SUBJECT: R.E. Ginna Nuclear Power Plant
Docket No. 50-244

**Response to Requests for Additional Information Regarding Topics
Described by Letter Dated November 3, 2005**

Subject: "Responses to NRC Requests for Additional Information (RAIs) RE: Extended Power Uprate License Amendment (TAC No. MC7382) Transmitted by Letter dated November 3, 2005 from Milano (NRC) to Korsnick (Ginna)"

Attachment 3
Response November 3 Request for Additional Information
NON-PROPRIETARY

Figure 1 – Steam Generator Mass vs. Time – HZP SLB

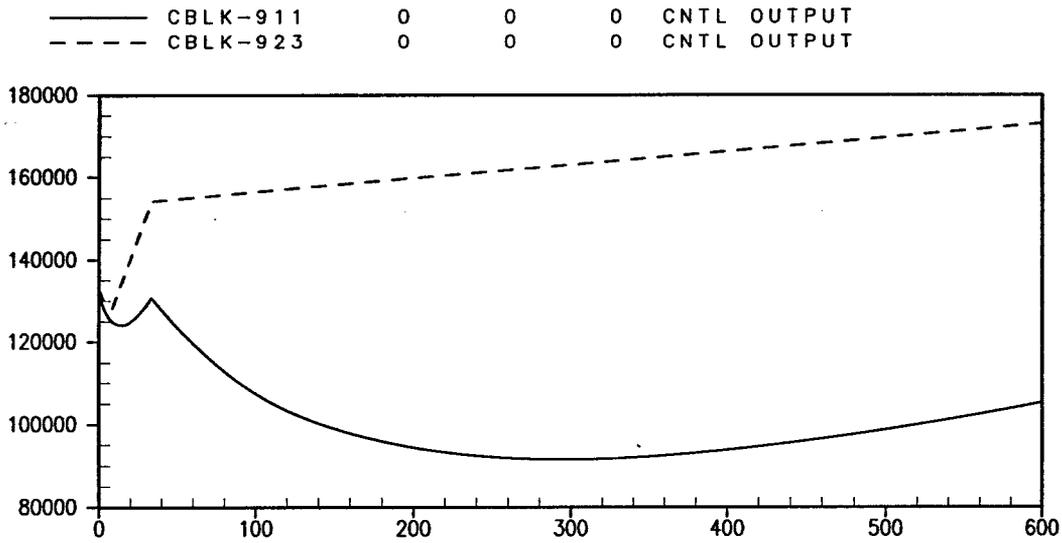
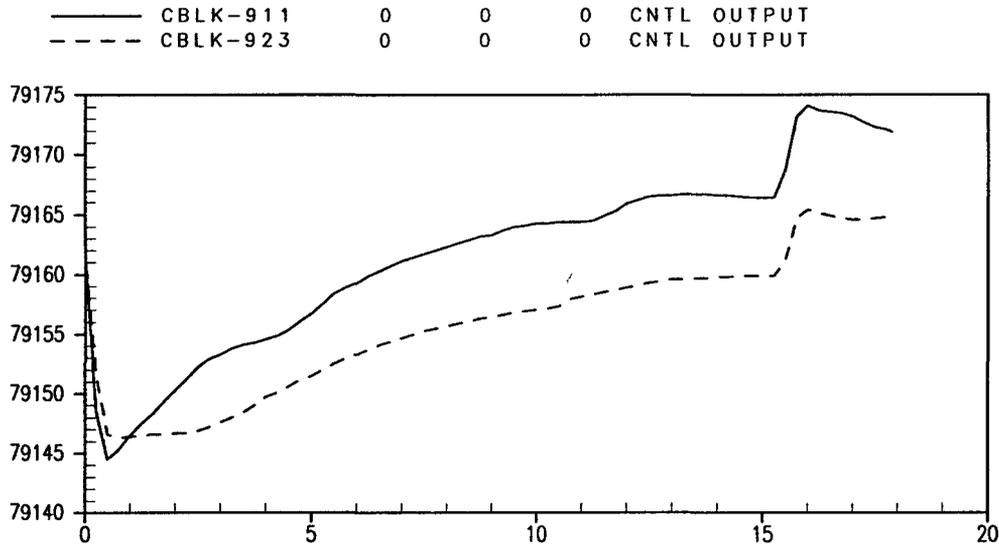
1. Provide a graph of SG mass versus time.
